BURFELL PROJECT

GENERAL APPRAISAL

**SWISS ALUMINIUM LTD.
ELECTRO-WATT
ZURICH**

NOVEMBER 1963

THE STATE ELECTRICITY AUTHORITY ICELAND			
BURFELL PROJECT			
ALTERNATIVE SCHEMES OF DEVELOPMENT			
ELECTRO-WATT	PPOJ. <i>Bur</i>	DATE: NOV. 1963	
ZURICH	DRAWN <i>Prof.</i>		
	APPRO. <i>Hansen</i>		NO. 50 397

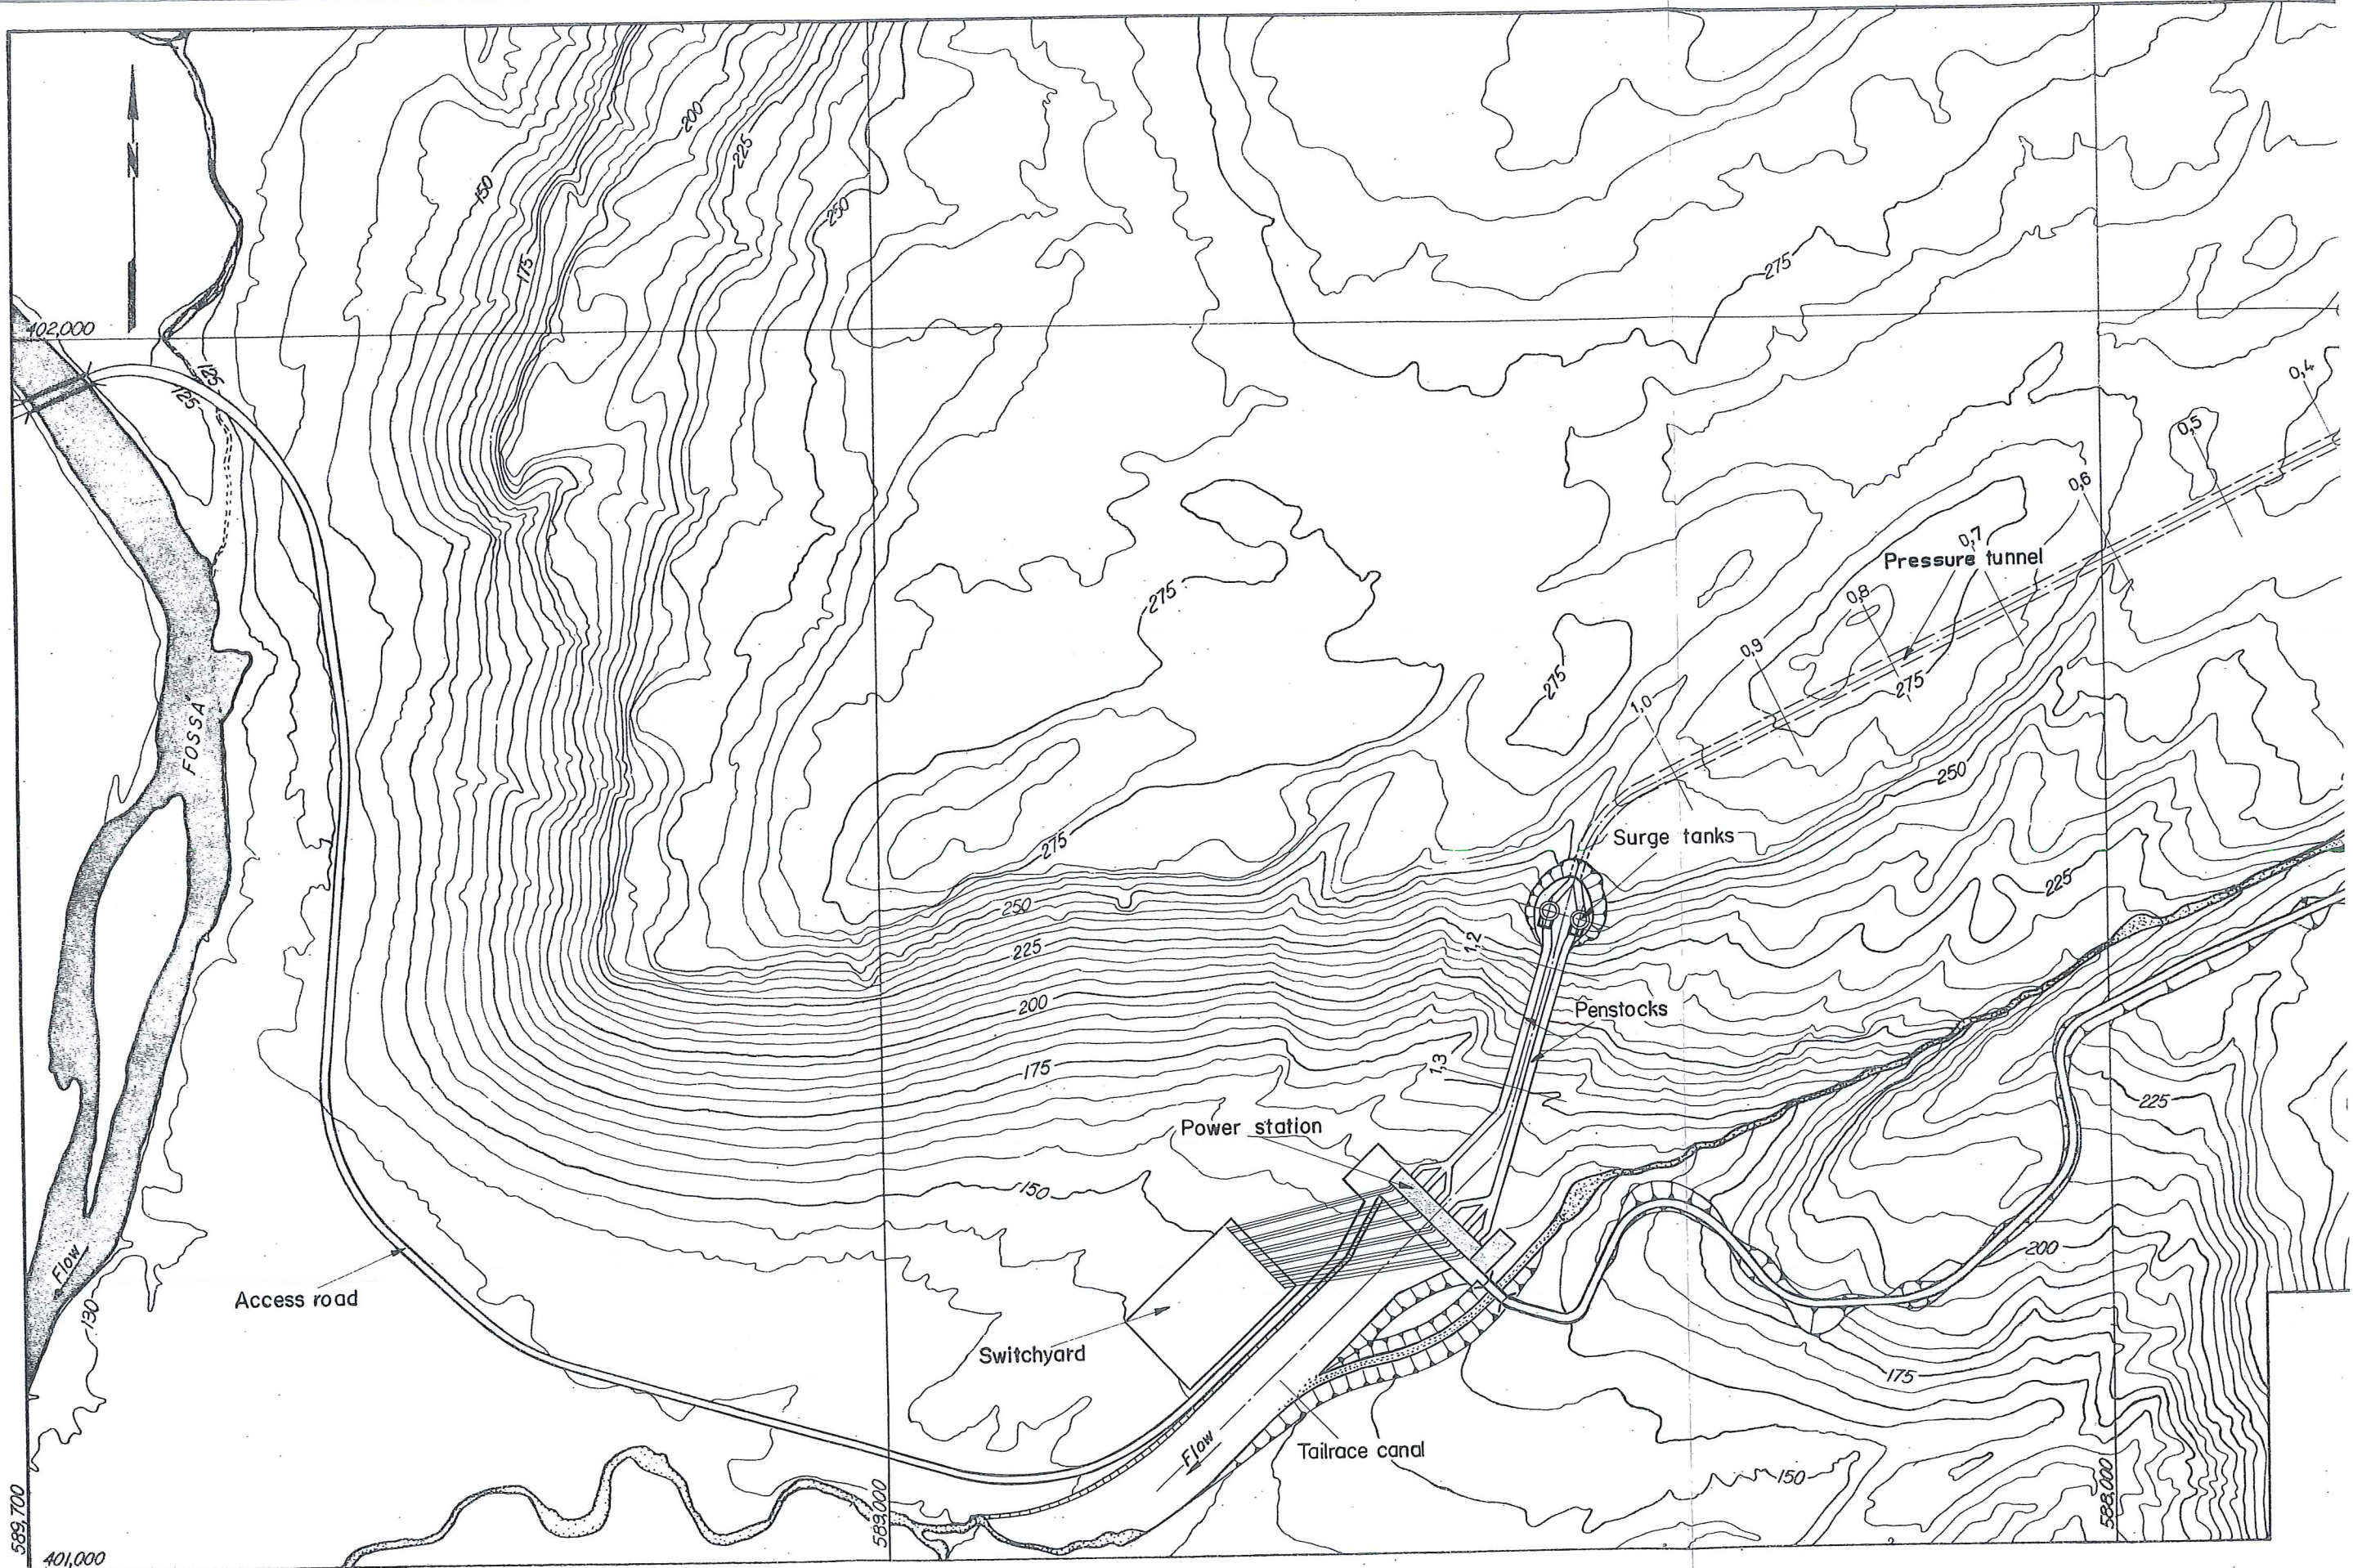
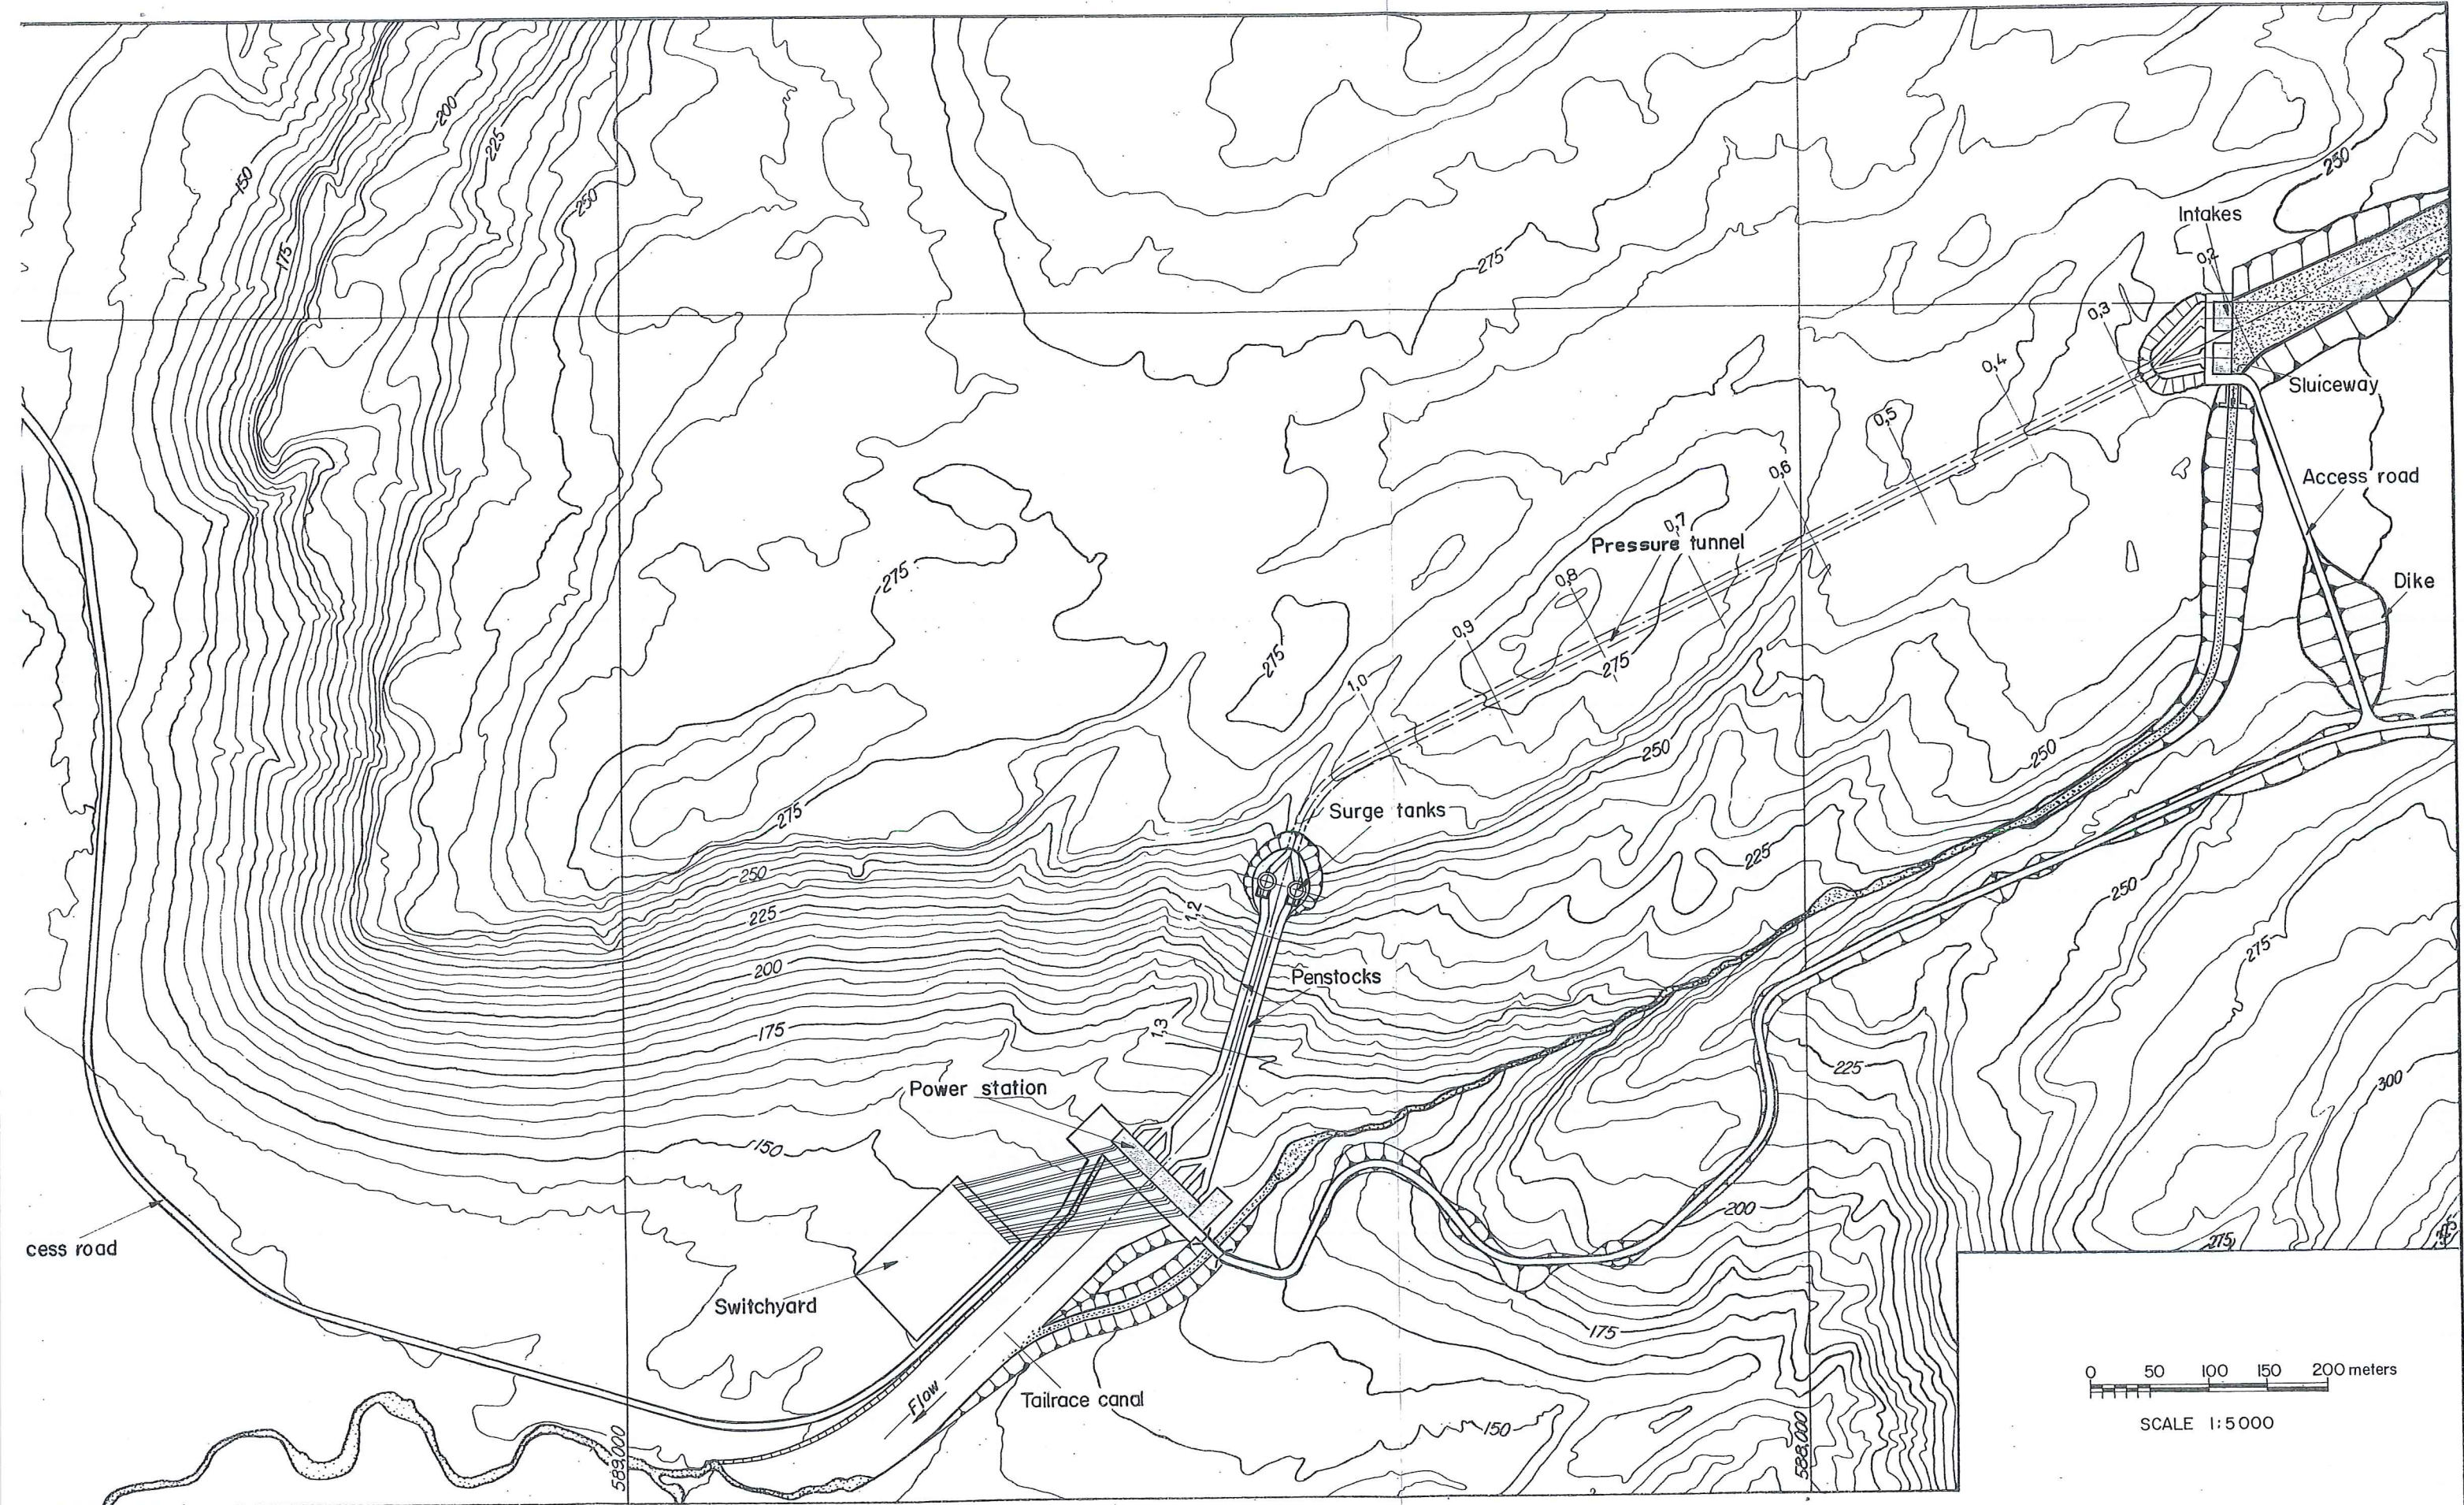
In the course of their investigations they have studied various alternate schemes developing the bend of the Thjorsà River near Burfell or the head existing between the Thjorsà River and its affluent the Fossà River in the same area. These various schemes are illustrated on drawing no. 50397. The Scheme C (see dwg. 50397) was recommended by Harza Engineering Company International as the most favourable of the alternate solutions suggested.

THE STATE ELECTRICITY AUTHORITY ICELAND			
BURFELL PROJECT			
ALTERNATIVE SCHEME - GENERAL LAYOUT.			
ELECTRO - WATT ZURICH	PROJ.	<i>Bru</i>	DATE: NOV. 1963
	DRAWN	<i>H.P.</i>	NO. 50 393
	APPRO	<i>Hansen</i>

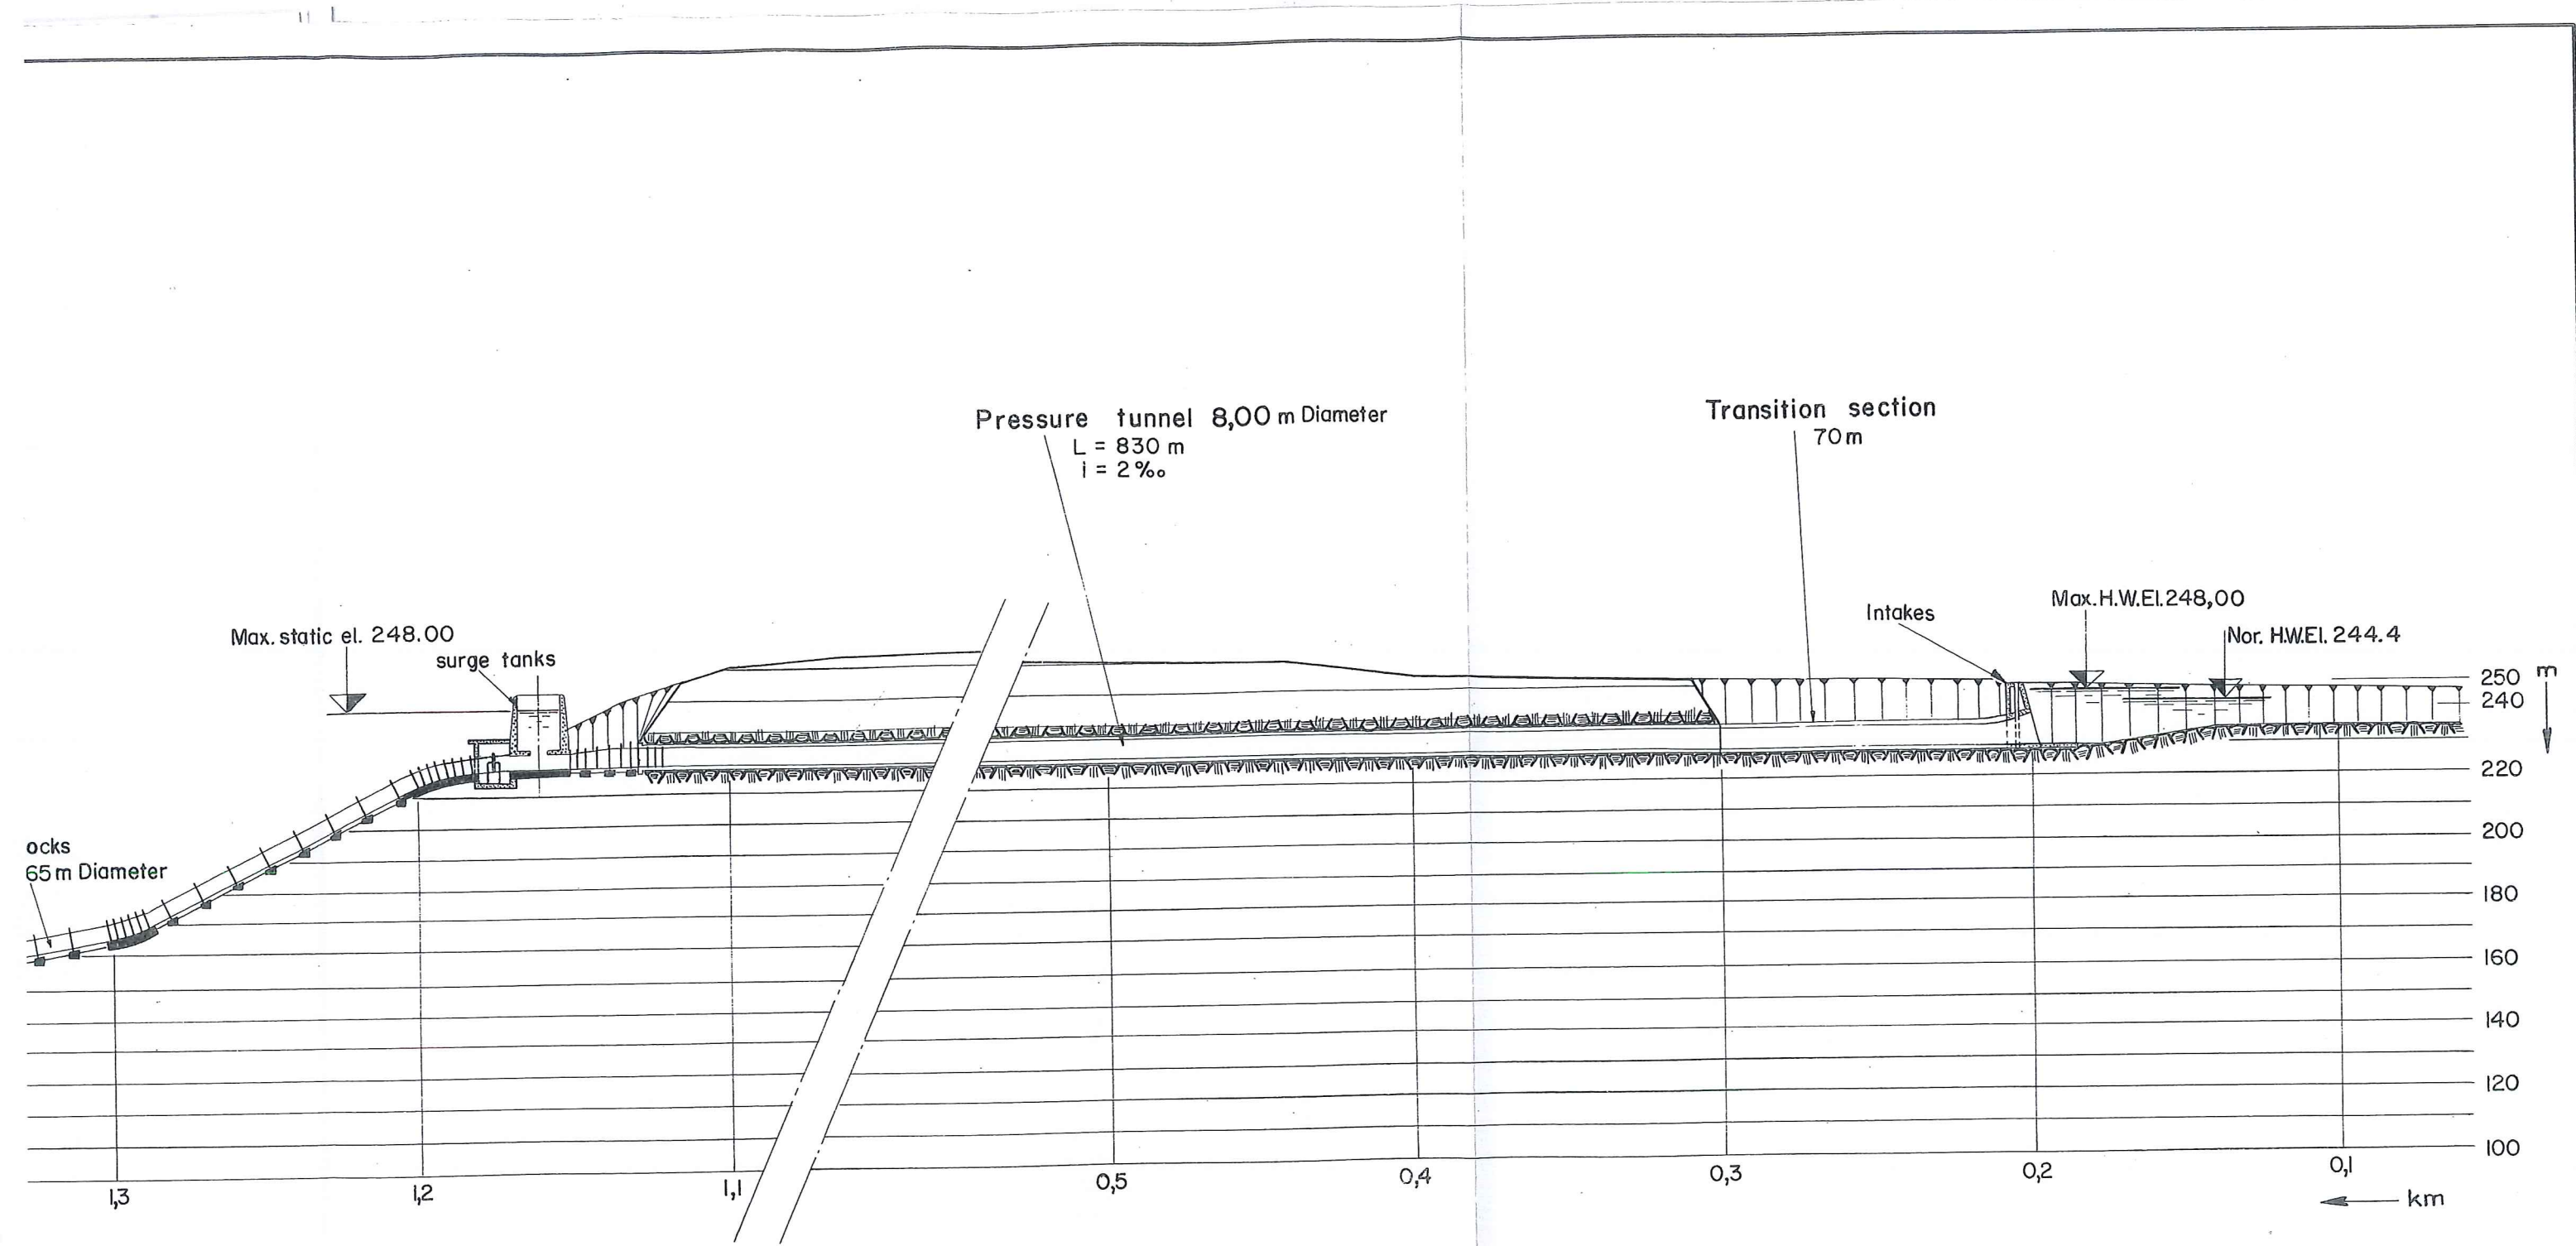
It appears that a headrace development with a powerhouse located near the bottom end of the Samsstadaklif would reduce the waterways considerably (900 m long head-race against 1700 m long tail-race) while the head developed would be only 15 percent less. The scheme suggested along these lines is shown on drawings no. 50393 and no. 50394. Diversion dams, intake and sluiceway would be located as in the Harza's Scheme C.

The intake structures and the sluiceway are identical with respect to their general concept, but have been moved about 80 m downstream along the line of the approach canal. A transition section leads to the pressure tunnel.

The pressure tunnel is 900 m long and has a diameter of 8.00 m. It is concrete lined over its whole length and can pass a maximum flow of 250 m³/s. The pressure tunnel will encounter basalts of the Samsstadaklif group. Excavation in this rock is not expected to present great difficulties. The minimum rock cover will be 15 m over the tunnel roof.

Two surge tanks will be provided at the lower end of the pressure tunnel. One only will be constructed during

the first stage of development. Two penstocks of 5.65 m diameter and 250 m length each are suggested, one only being provided in the first stage.
